DS-K1T671 Series MinMoe Terminal

Release Notes (2023-10-19)

Device Model: DS-K1T671M/MF DS-K1T671TMW/TMFW	Firmware Version	ARM: ACS_671_AI3_EN_STD_V3.7.0_build231019 ACS_671_AI3_EN_NEU_V3.7.0_build231019
	Software Version	HikCentral AC: https://www.hikvision.com/en/support/download/software/hikcentral-access-control-v2-1/
Naming Rule: M for M1 card, W for WIFI, F for fingerprint

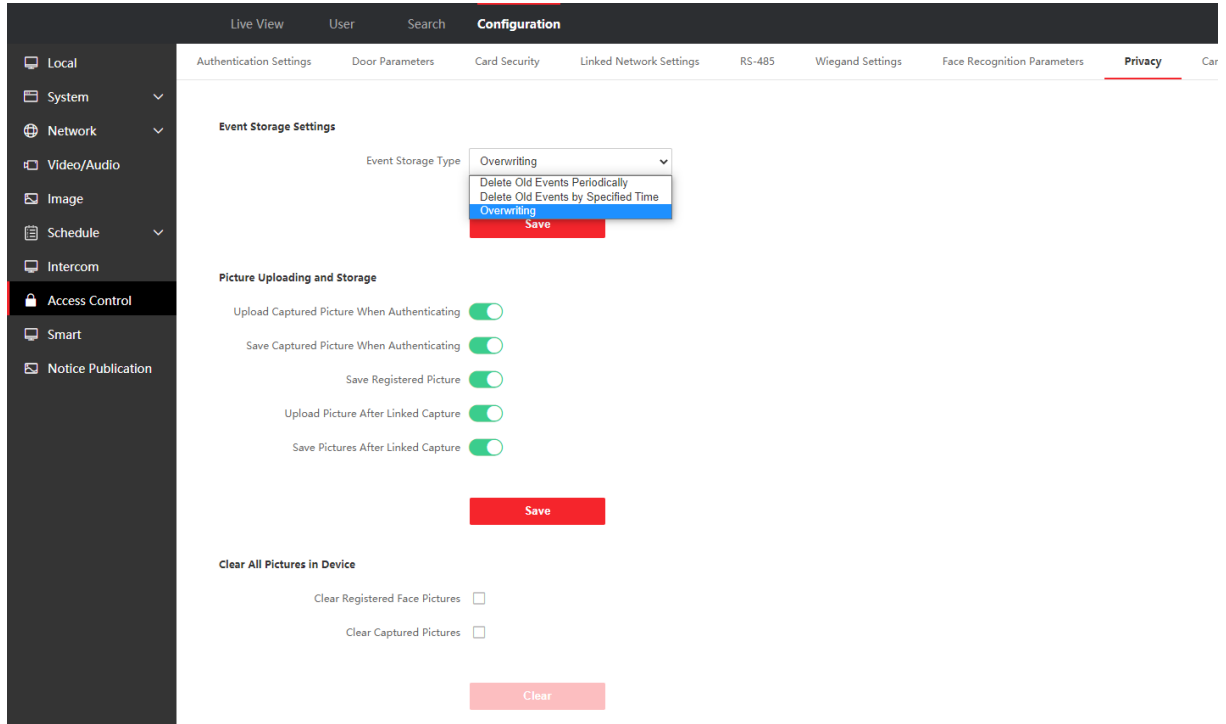
11. Add privacy protection, customer can define the privacy related parameter, such as Event Storage Settings, Picture Uploading and Storage, Clear All Pictures in Device

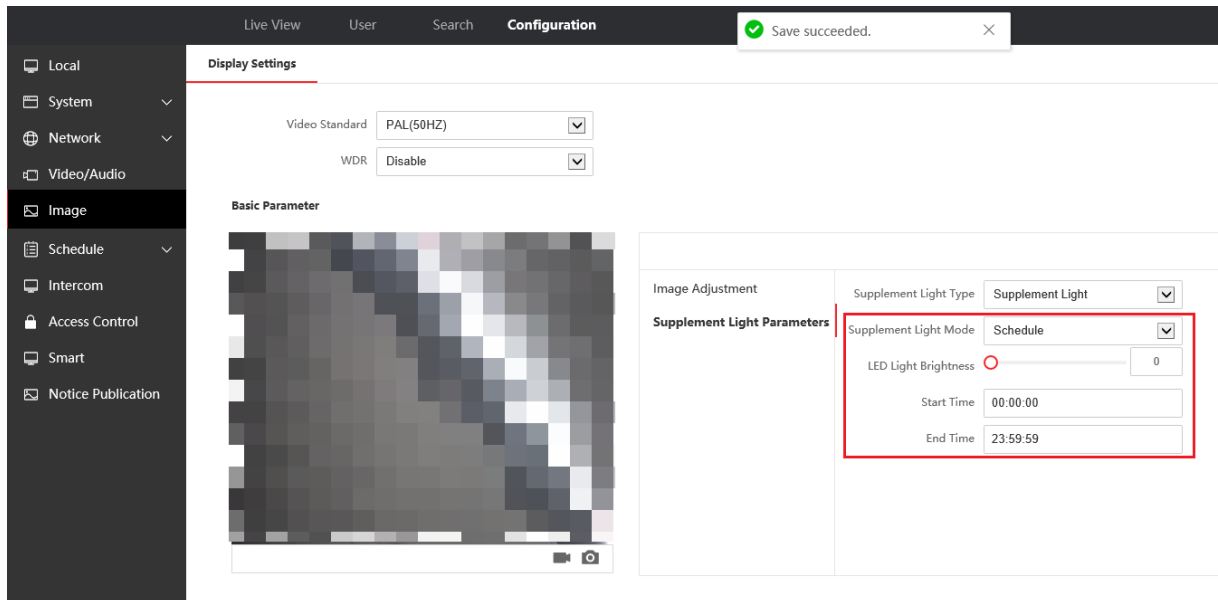
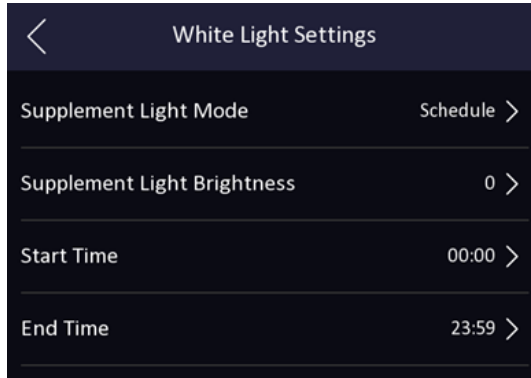
12. Configure the time period when the white light fill light is turned on and off in device local menu or web interface

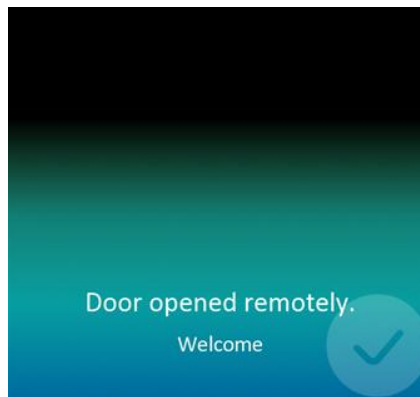
13. Add audio prompt 'The door is open' when open door on iVMS4200, HikCentral Pro, Hik-Connect App, and device UI will show prompt

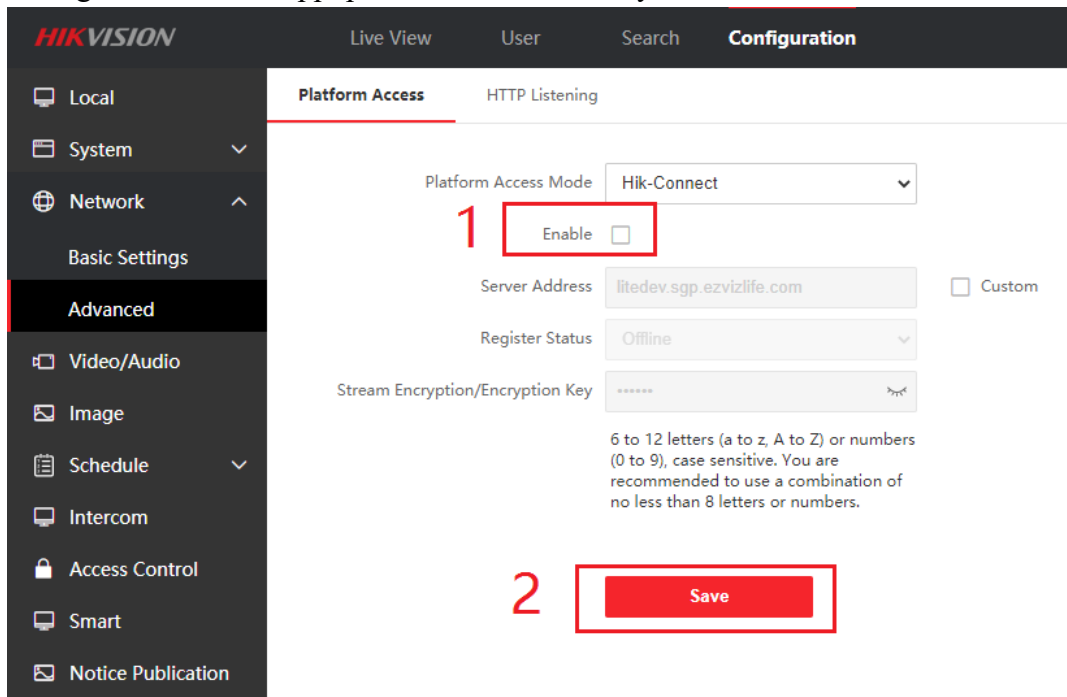
4. Hik-Connect function is turned off in default for privacy protection, if customer want to manage device from App, please turn on manually in the web.

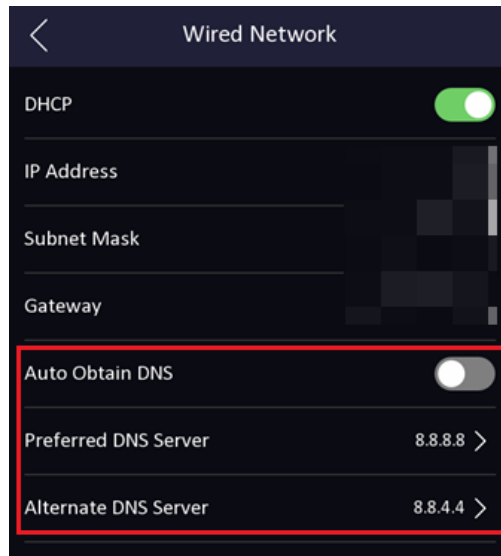
- 5. The face matching algorithm is upgraded. Improve the speed and accuracy of face recognition. Improved the recognition effect of dark masks
- 6. DNS can be configured from device UI in menu → Comm.-->Wired Network

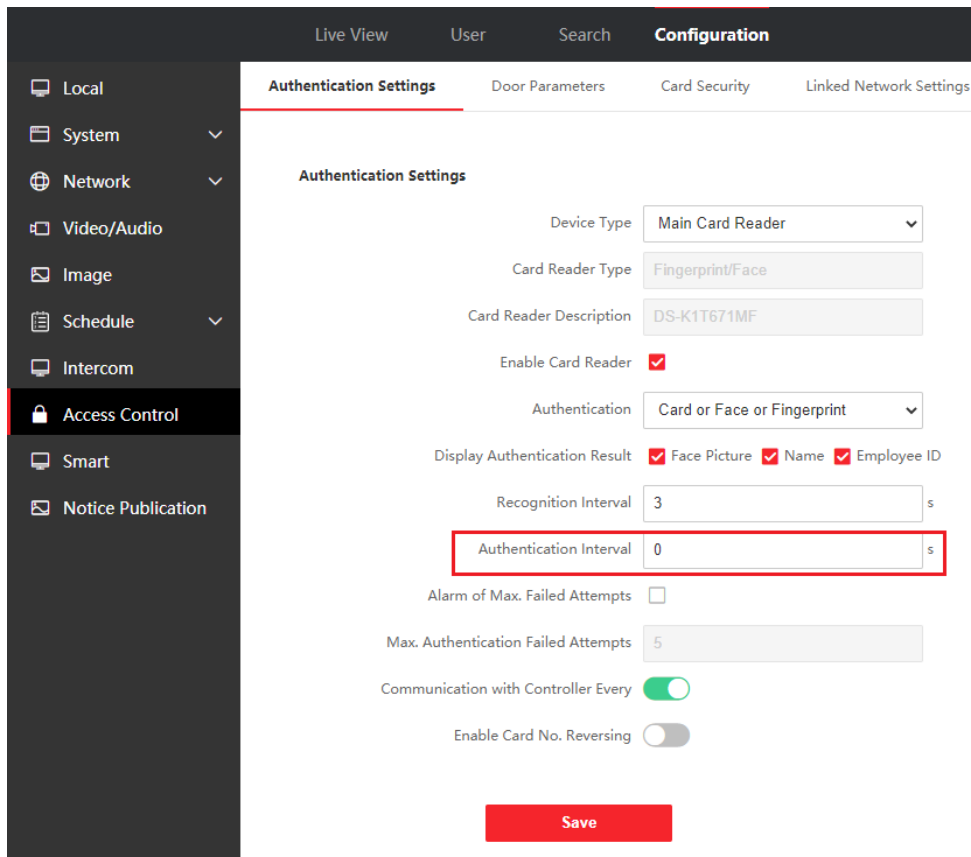
- 7. Optimized the ISUP and Hik-Connect event upload mechanism.
- 8. Add stranger authentication timeout time configuration

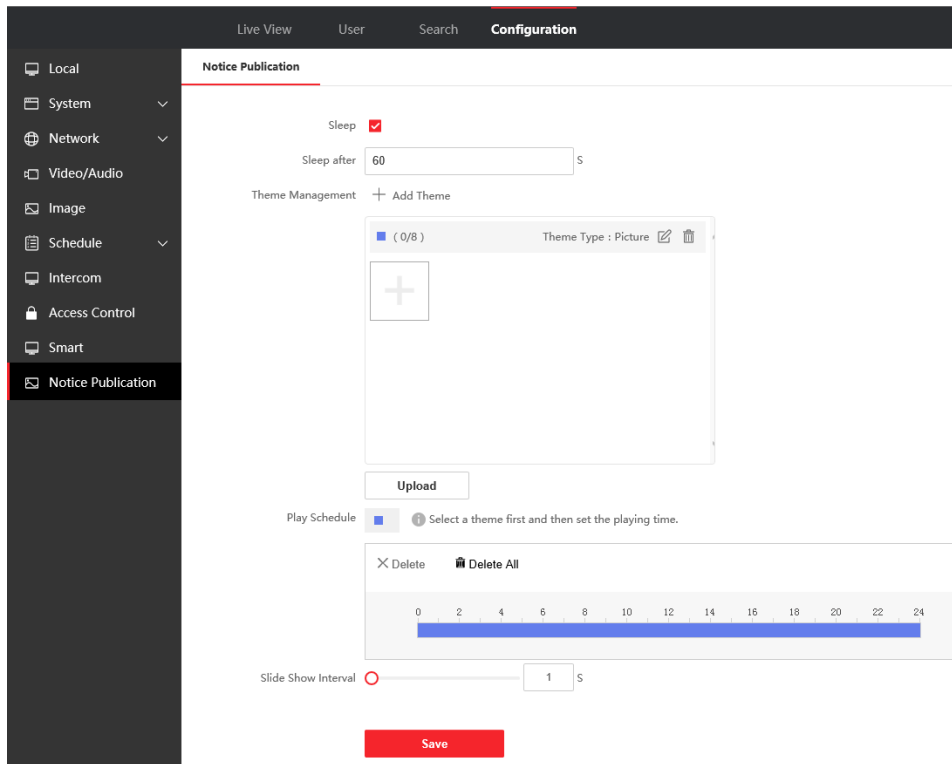
- 9. Add advertisement/wallpaper play schedule configuration, slide show interval.
